ADDENDUM NO. 1 TO PLANS AND CONTRACT DOCUMENTS

**Franklin Canal Flood Protection System Phase II Pump Station
TV-52**

**STATE OF LOUISIANA
COASTAL PROTECTION AND RESTORATION AUTHORITY**

May 28, 2014

SHEET C-002

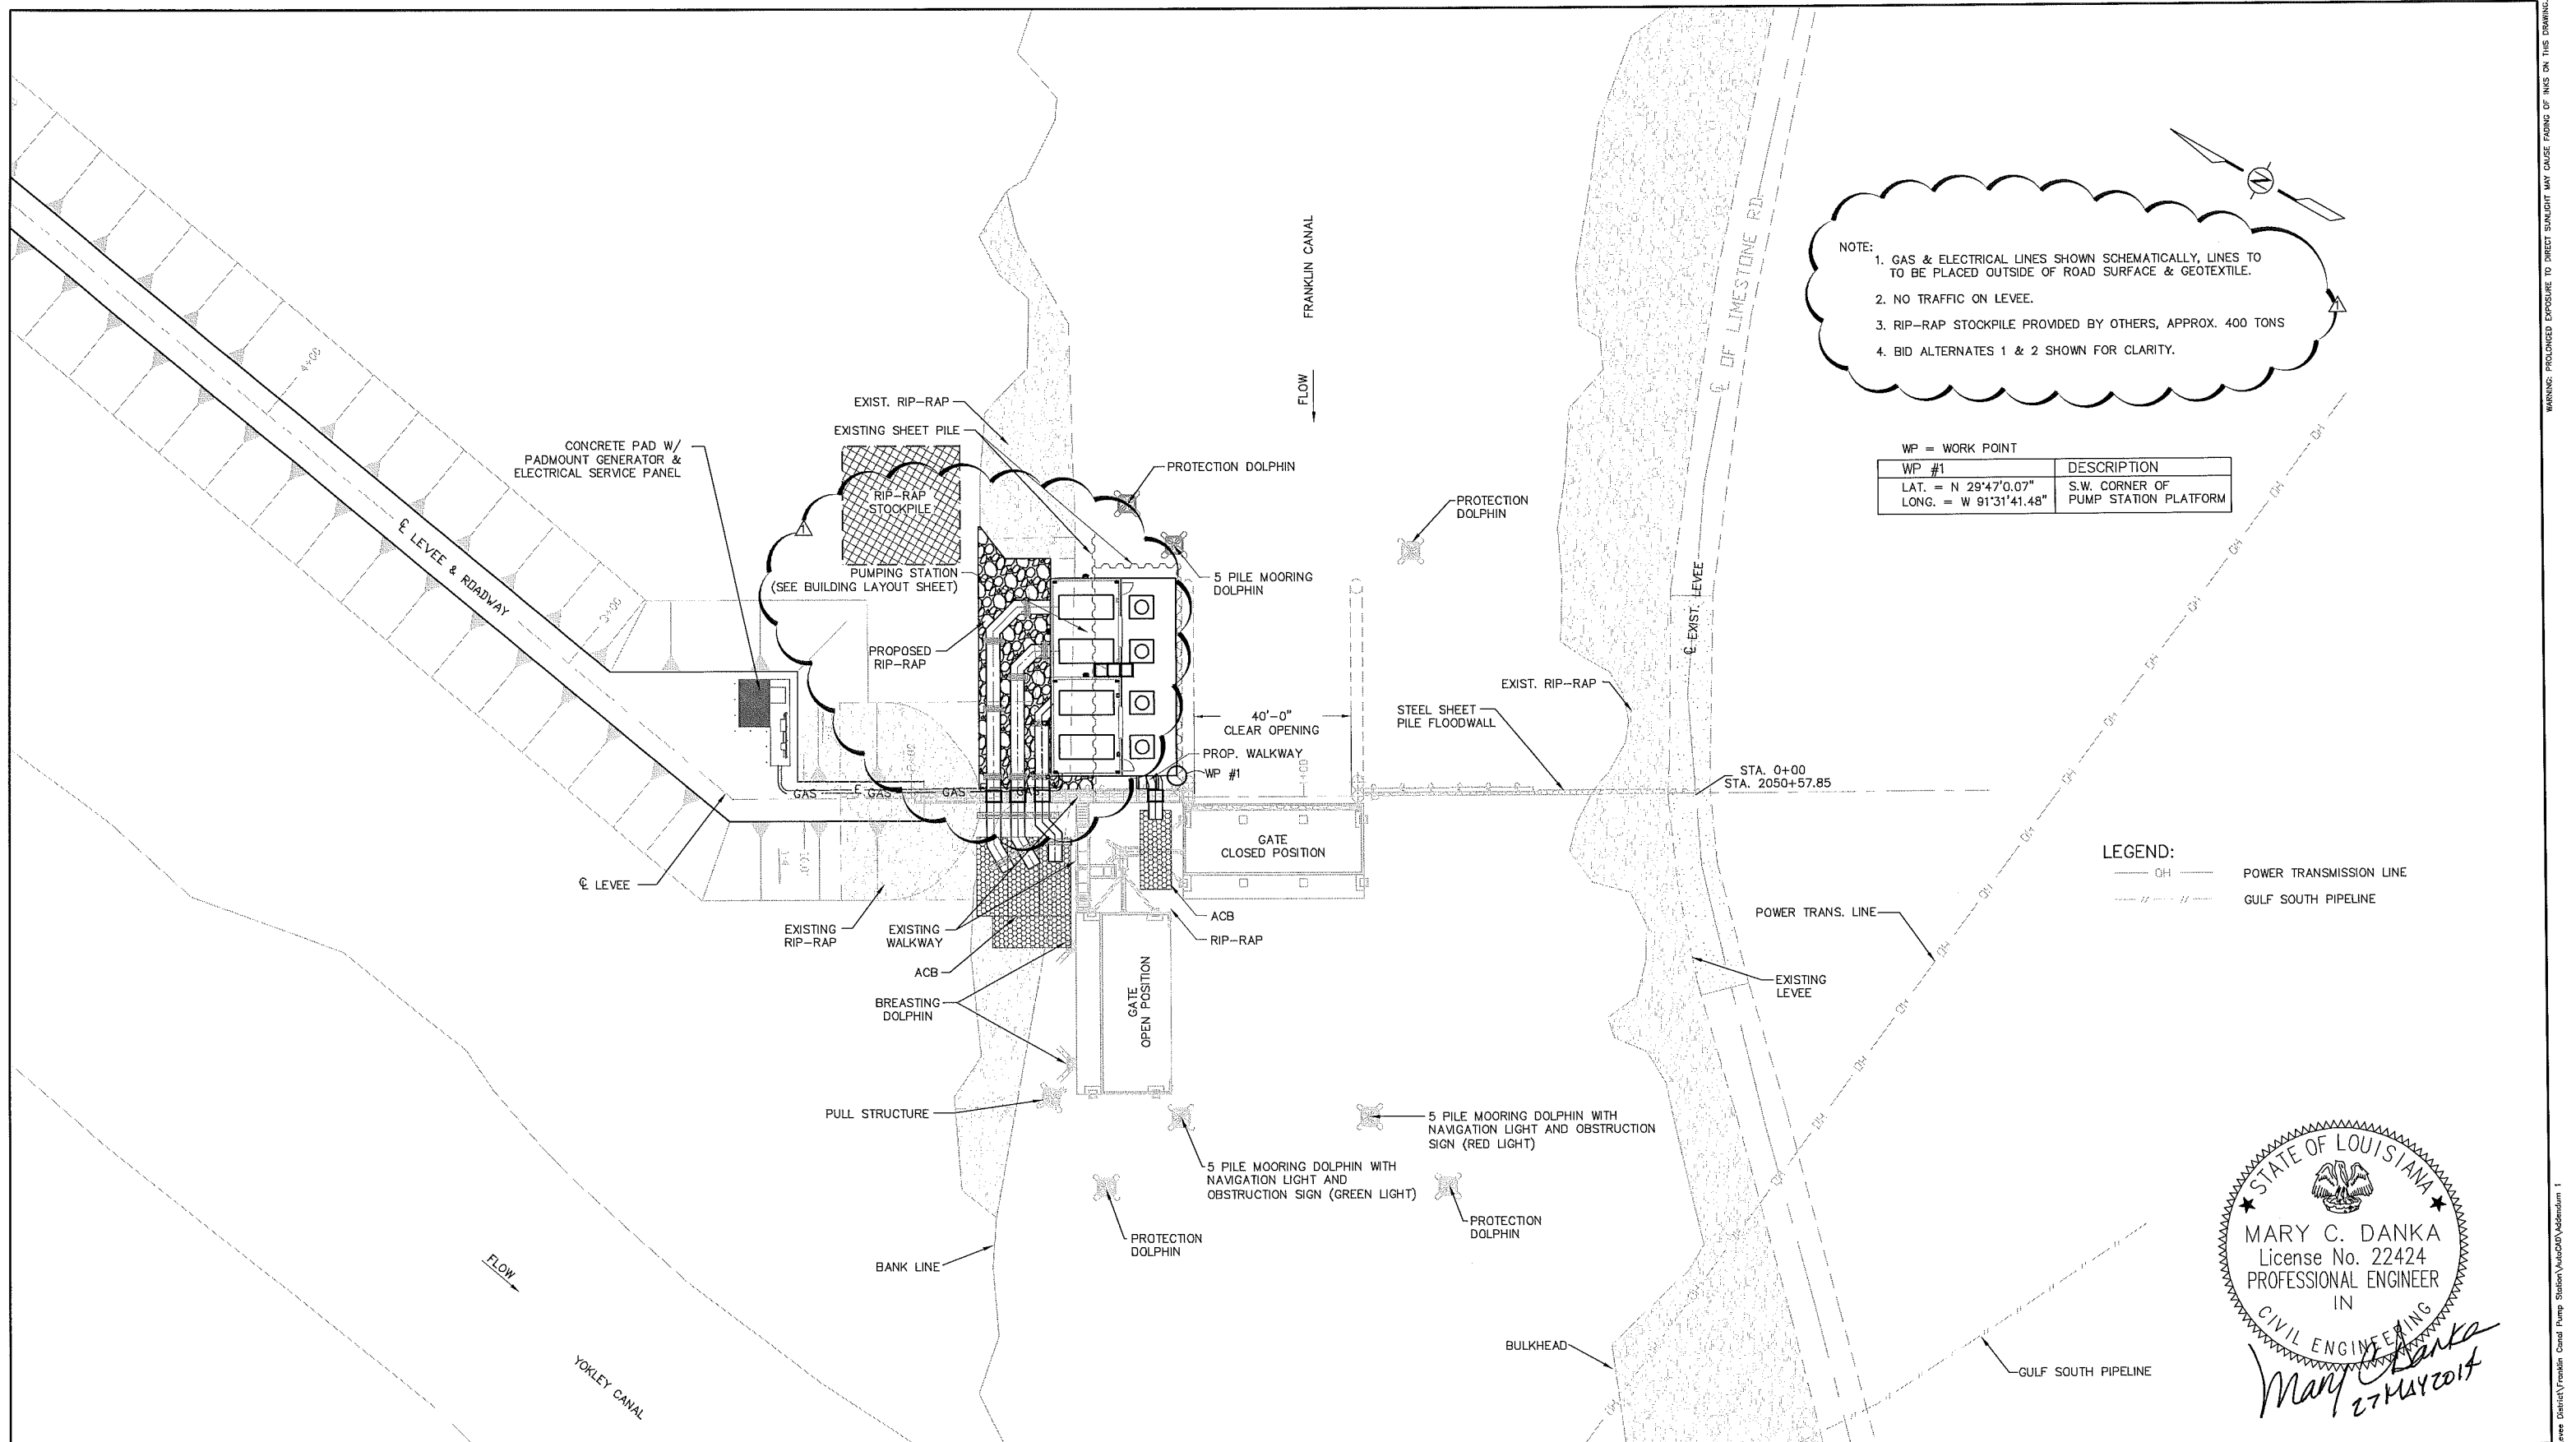
- A. Sheet C-002
Note No. 3 revised and placement of proposed rip rap identified.
- B. Sheet C-003
Placement of rip rap identified.
- C. Sheet S-004
Notes and pile details revised.
- D. LADOTD Standard Detail BD 2.5.1.0.2 – CS-216
Add Sheet to Plan Set.
- E. Sheet G-003
Revise Steel Note 1.C.1. “API 5L PSL 1 GRADE X42, NO SPIRAL WELDS, Fy=42 ksi” to read “API 5L PSL 1 GRADE X42, Fy=42 ksi”

1. GAS & ELECTRICAL LINES SHOWN SCHEMATICALLY. LINES TO BE PLACED OUTSIDE OF ROAD SURFACE & GEOTEXTILE.
2. NO TRAFFIC ON LEVEE.
3. RIP-RAP STOCKPILE PROVIDED BY OTHERS, APPROX. 400 TONS
4. BID ALTERNATES 1 & 2 SHOWN FOR CLARITY.
